# White Rose Carbon Capture and Storage (CCS) Project

# **Environmental Permit Chapter XIII – BAT Statement**

**Applicant: Drax Power Limited**

Date: June 2015

#### <u>Design</u>

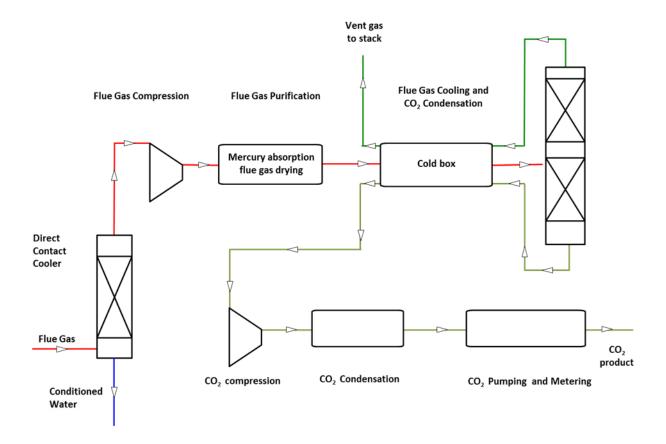
16. and 54. Provide detail of design and emissions for GPU and enhance description of GPU;

The CO<sub>2</sub> processing and compression will be undertaken in the Gas Process unit (GPU). The purpose of the GPU is to purify and compress the CO<sub>2</sub> rich flue gas and to provide a CO<sub>2</sub> product stream that meets the specification for onward transport and storage.

The flue gas at the inlet of the GPU has the following main components:  $CO_2$ ,  $H_2O$ , inert gas and oxygen. The GPU is designed to process the full flue gas stream. The main purpose is to remove the inert gas and the oxygen from the flue gas in order to produce a high purity  $CO_2$  product. The residual vent gas is sent to the main stack. A CEMS is installed to monitor the emission level.

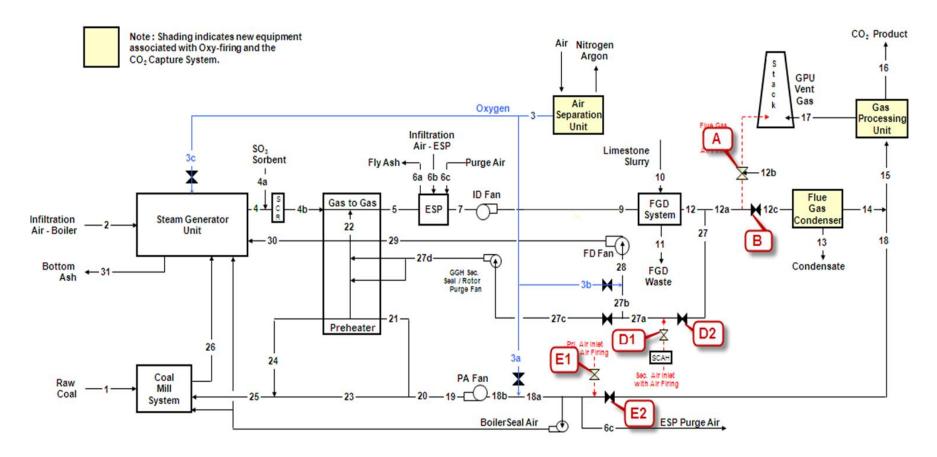
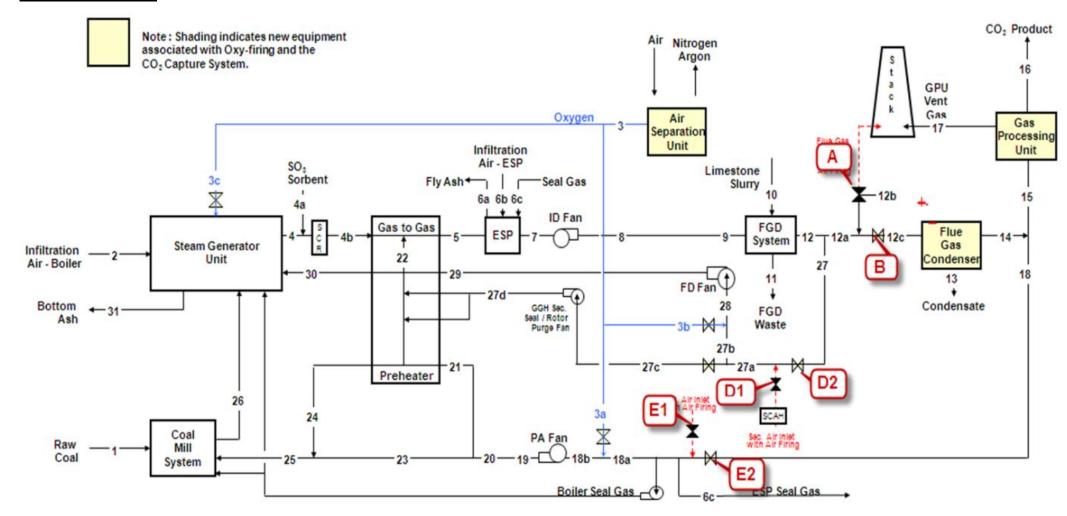
- Corrosion resistant ducts specified upstream of the PA and FD fans
- FD fan design includes stainless steel liner and cast iron or stainless steel impellers
- 24. Provide information regards how the dynamic burner transition air -> oxy is to be managed;

Answer: The start-up of the plant is in air mode. The normal transition from air to oxy mode takes place between 40% to 50% load. The normal transition load range from oxy mode to air mode will take place in the same range.

In the transition from air mode to oxy mode, the oxidant streams supplied to the furnace through the PA and FD fans are progressively transitioned from air drawn from the atmosphere to a mixture of GOX from the ASUs and recirculated flue gases. Switching from air mode to oxy mode takes about one hour. Once oxy-firing is established, the resultant CO<sub>2</sub> rich flue is introduced to the GPU, and once the CO<sub>2</sub> specification is achieved OPP full CCS operation can commence.

Figure H.1 Plant Layout

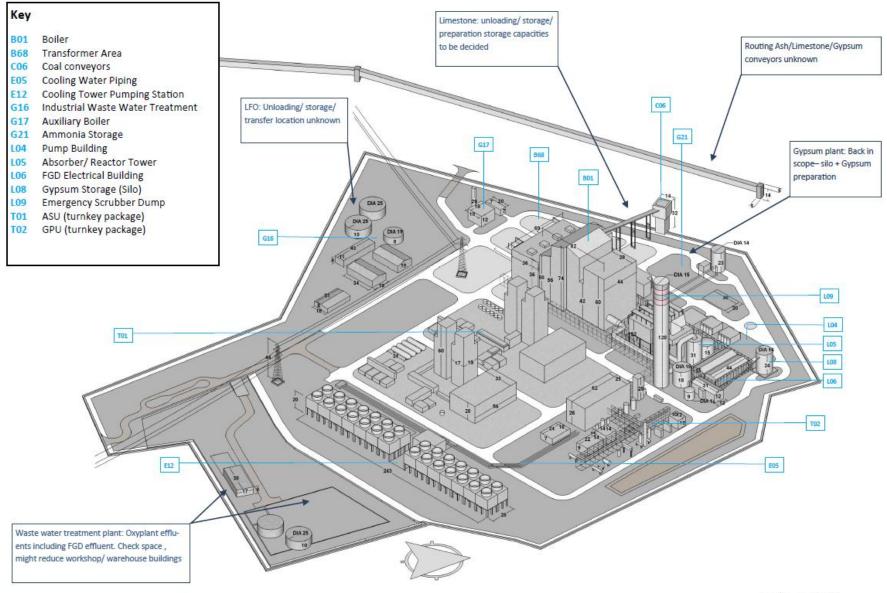
Question 36. Provide a diagram indicating Plant Layout and Air Flows

Answer: Appendix 1
